STATE OF MARYLAND
DEPARTMENT OF TRANSPORTATION
STATE HIGHWAY ADMINISTRATION
OFFICE OF TRAFFIC & SAFETY
TRAFFIC ENGINEERING DESIGN DIVISION
US 1 BUSINESS @ ATWOOD ROAD

1	REDLINE NO. 1 ADDED 5 FT. PEDESTAL POLE. SHA. CONTRACT NO. XX4275185 1/10/2011	TIMS #K235
2	UPGRADE TO APS/CPS SHA. CONTRACT NO. XX4275185 TIMS #K235 08/10/2010	
3	INSTALL VIDEO DETECTION SHA. CONTRACT NO. 01 2005 TIMS #H394 11/05

TRAFFIC SIGNALIZATION PLAN

TS NO. 1962 DRAWING TSP-1 OF 3 SHEET NO. 1 OF 3

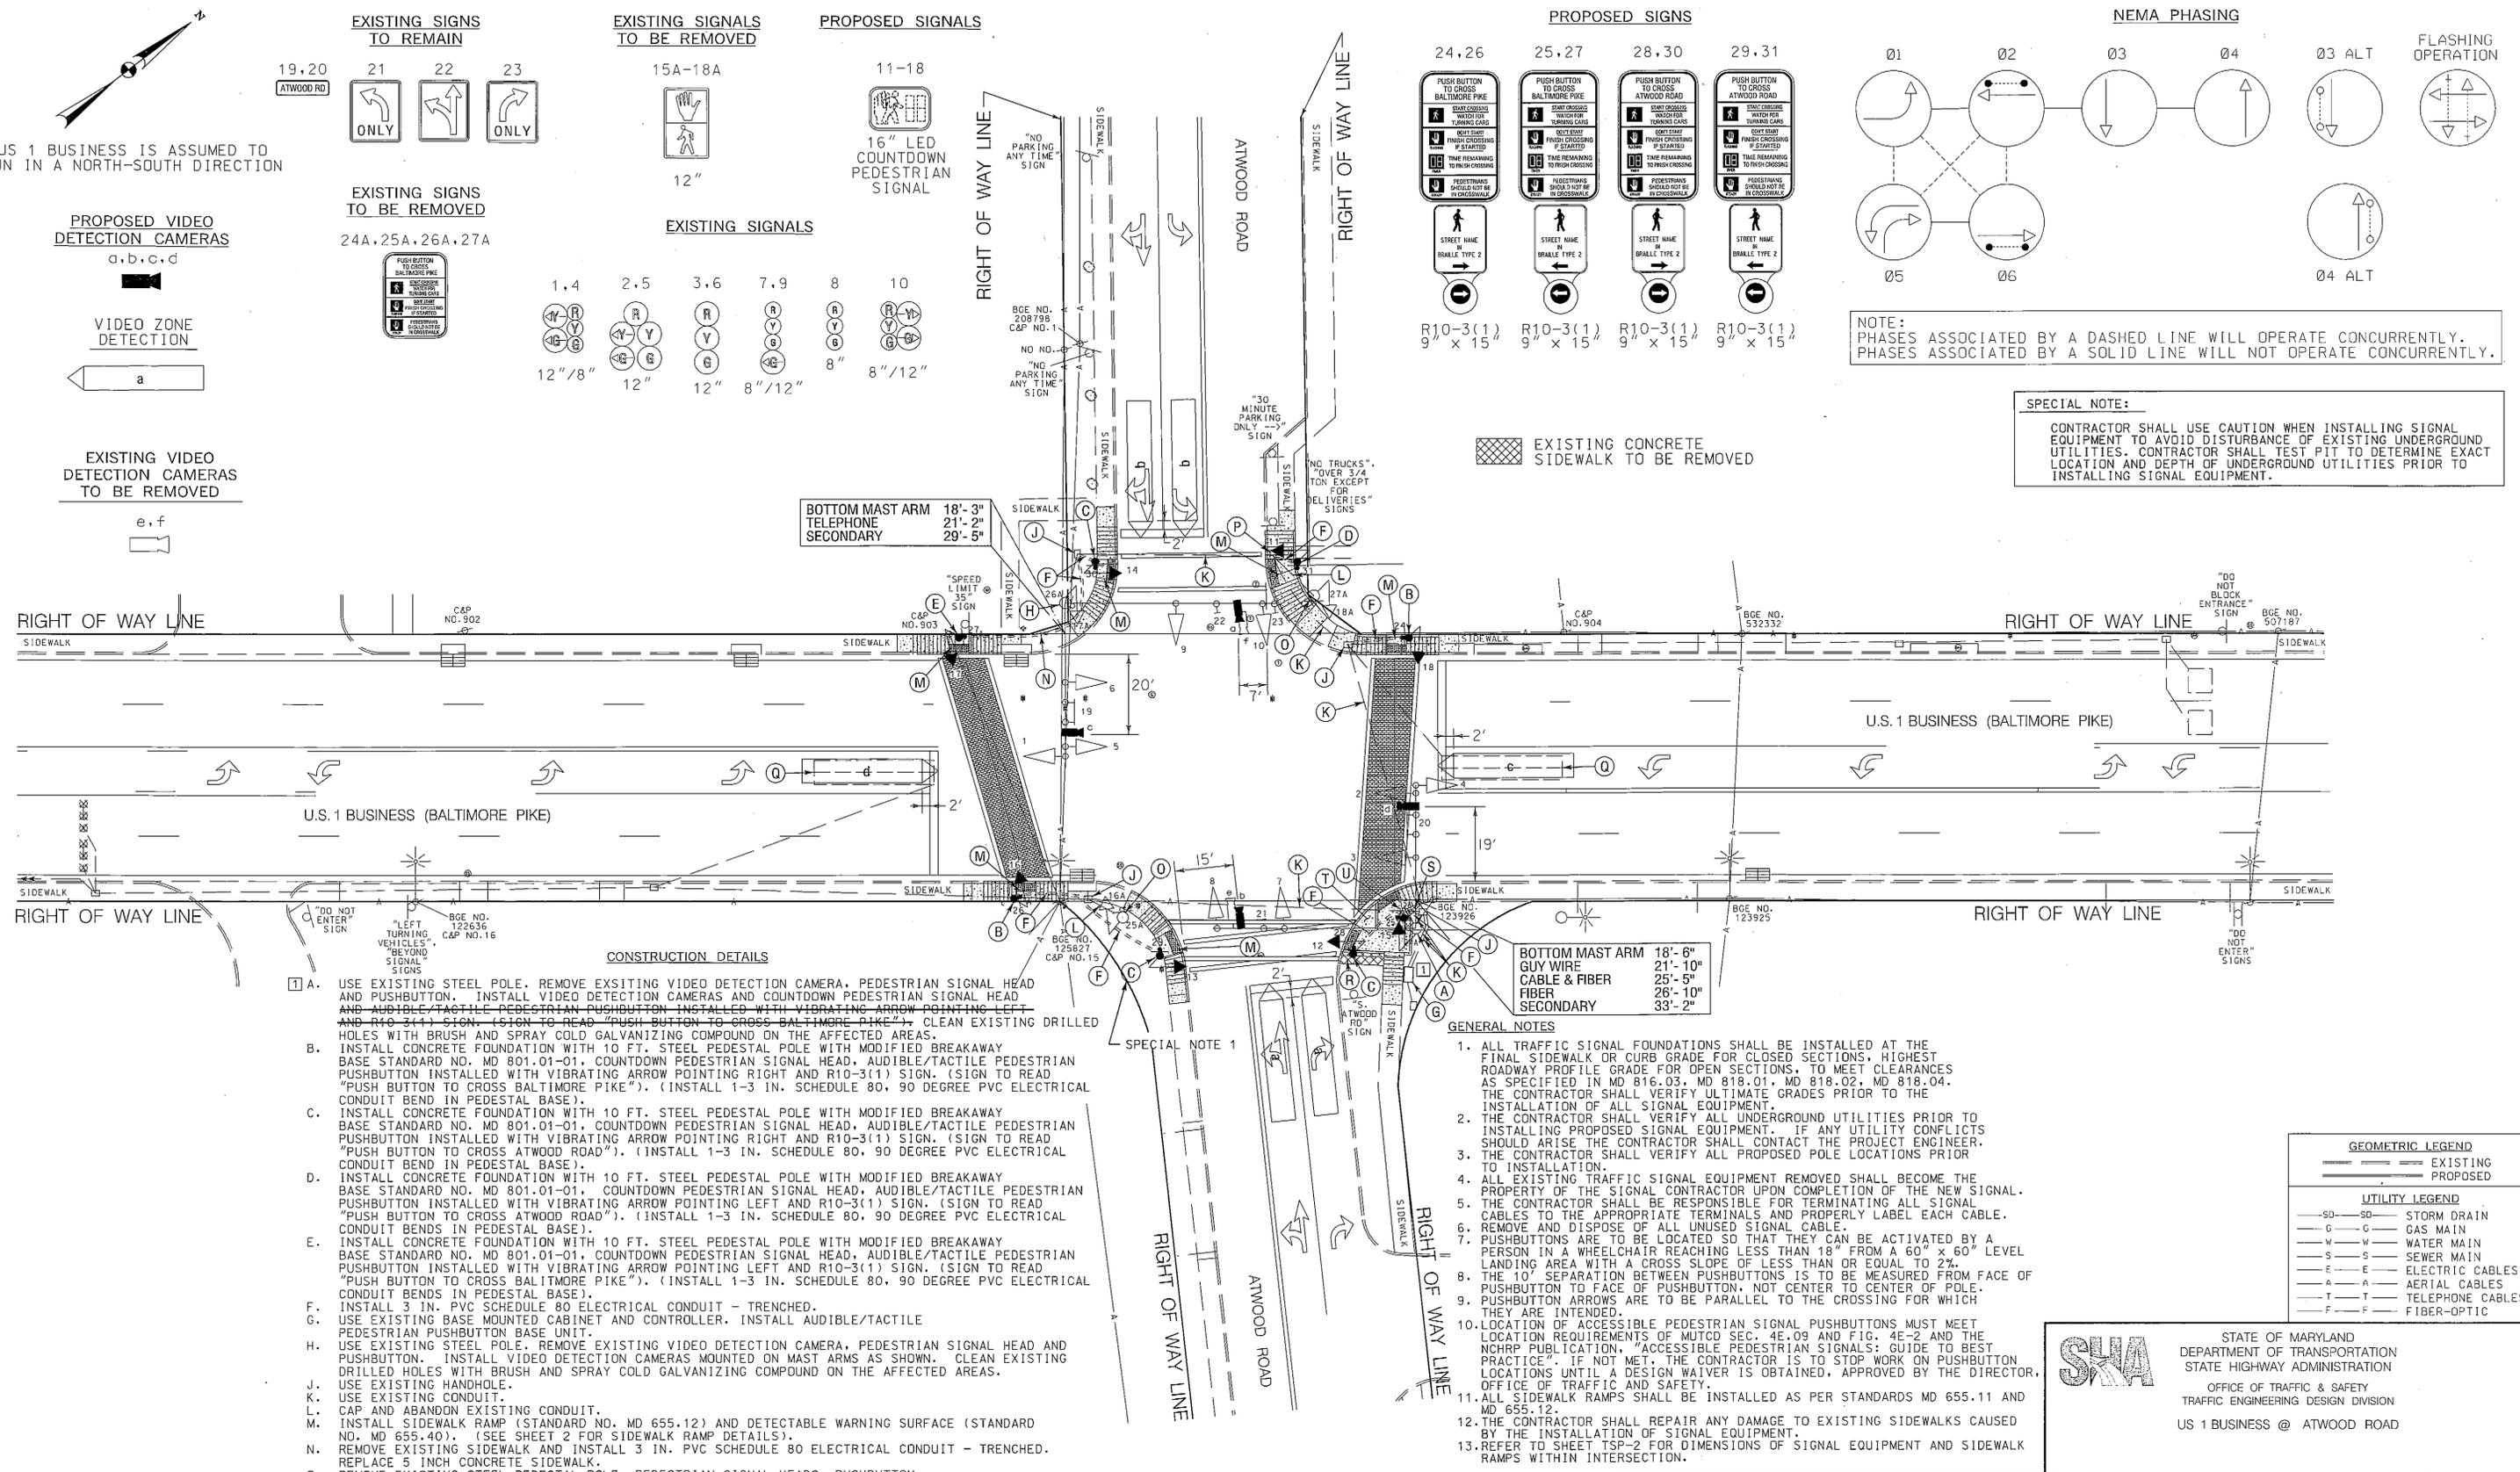
- INSTALL CONCRETE FOUNDATION WITH 5 FT. STEEL PEDESTAL POLE WITH MODIFIED BREAKAWAY BASE STANDARD NO. MD 801.01-01, COUNTDOWN PEDESTRIAN SIGNAL HEAD, AUDIBLE/TACTILE PEDESTRIAN PUSHBUTTON INSTALLED WITH VIBRATING ARROW POINTING LEFT AND R10-3(1) SIGN. (SIGN TO READ "PUSH BUTTON TO CROSS BALTIMORE PIKE"). (INSTALL 1-3 IN. SCHEDULE 80, 90 DEGREE PVC ELECTRICAL CONDUIT BEND IN PEDESTAL BASE).
